AMENDMENTS TO THE DRAWINGS

REMARKS

[FIG. 6]

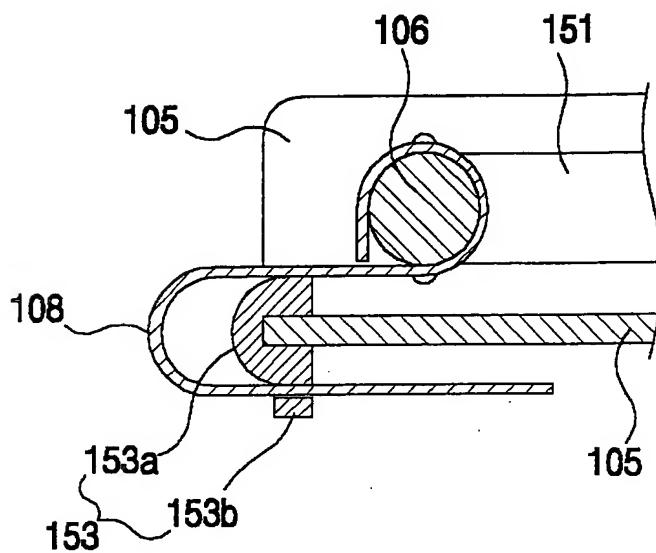
The attached two sheets of drawings include changes to figures 6 and 8. The first sheet, which includes figures 5 and 6, replaces the original sheet including figures 5 and 6. In figure 6, the representation of elements 102 and 105 have been corrected. The second sheet, which includes figure 8, replaces the original sheet including figure 8. In figure 8, the representation of element 108 has been corrected.

The Examiner has objected to the drawings as failing to properly show Applicant's invention in operation. In response thereto, Applicant has submitted herewith two replacement sheets of drawings including the required corrections. For the Examiner's convenience, Applicant has also submitted herewith two annotated drawing sheets showing the changes in red ink. Accordingly, in view of the above noted
